# Nitric Acid Production Project Protocol, Version 1.0 ERRATA AND CLARIFICATIONS

March 17, 2011

Section: 4.1, Figure 4.1 - Secondary Catalysts Project, GHG Assessment Boundary

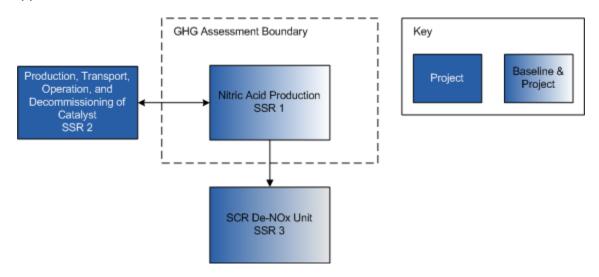
**Context:** Figure 4.1 provides a general illustration of the GHG Assessment Boundary for secondary catalyst projects, indicating which SSRs are included or excluded from the boundary. It includes SSR 3 – SCR De-NOx Unit within the boundary, while the corresponding Table 4.1 correctly excludes SSR 3 from the boundary.

**Correction:** SSR 3- SCR De-NOx Unit was erroneously included within the boundary in Figure 4.1. SSR 3 should be excluded from the GHG Assessment Boundary in Figure 4.1, making it consistent with Table 4.1. The effect of SCR de-NOx technology on  $N_2O$  emissions is not only small, but also equivalent in the baseline and project. The corrected Figure 4.1 appears below.

**Section:** 4.2, Figure 4.2 - Tertiary Catalyst Project with Existing SCR De-NOx, GHG Assessment Boundary

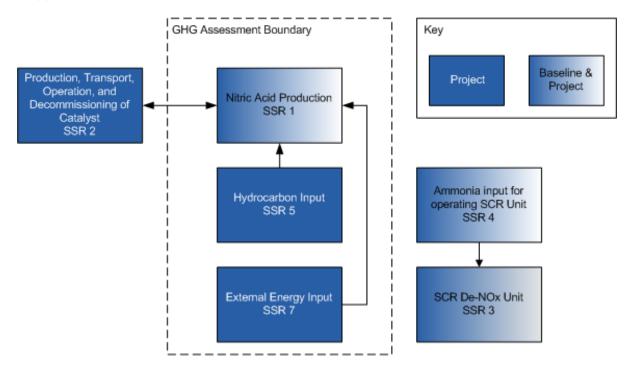
**Context:** Figure 4.2 provides an illustration of the GHG Assessment Boundary for tertiary catalyst projects with existing SCR De-NOx units operating prior to the project start date, indicating which SSRs are included or excluded from the boundary. It includes SSR 3 – SCR De-NOx Unit within the boundary, while the corresponding Table 4.2 correctly excludes SSR 3 from the boundary.

**Correction:** SSR 3- SCR De-NOx Unit was erroneously included within the boundary in Figure 4.2. SSR 3 should be excluded from the GHG Assessment Boundary in Figure 4.2, making it consistent with Table 4.2. The effect of SCR de-NOx technology on  $N_2O$  emissions is not only small, but also equivalent in the baseline and project. The corrected Figure 4.2 appears below.

**Section:** 4.2, Figure 4.3 - Tertiary Catalyst Project without Existing SCR De-NOx, GHG Assessment Boundary

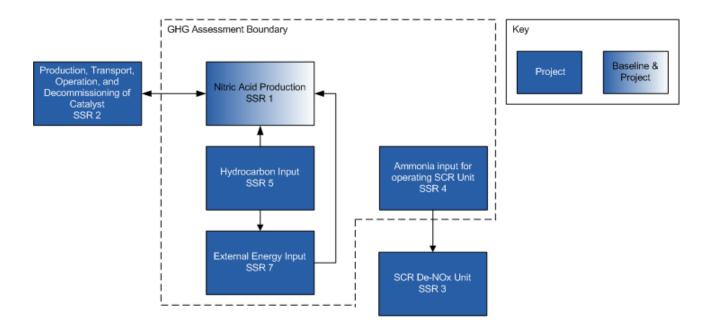
**Context:** Figure 4.3 provides an illustration of the GHG Assessment Boundary for tertiary catalyst projects without existing SCR De-NOx units operating prior to the project start date, indicating which SSRs are included or excluded from the boundary. It includes SSR 3 – SCR De-NOx Unit within the boundary, while the corresponding Table 4.2 correctly excludes SSR 3 from the boundary. The effect of SCR de-NOx technology on  $N_2O$  emissions is assumed to be minimal and therefore not necessary to include. Additionally, SSR 3 and SSR 4 – Ammonia Input for operating SCR Unit are both erroneously shaded to indicate emissions are relevant in both the baseline and the project.

**Corrections:** SSR 3 – SCR De-NOx Unit was erroneously included within the boundary in Figure 4.3. SSR 3 should be excluded from the GHG Assessment Boundary in Figure 4.3, making it consistent with Table 4.2. In addition, SSR 3 and SSR 4 should both be colored solid blue, to indicate that emissions from these sources are only relevant in the project. The SCR de-NOx unit and the ammonia used to operate it are added in conjunction with the tertiary catalyst, and are therefore not present in the baseline. The corrected Figure 4.3 appears below.
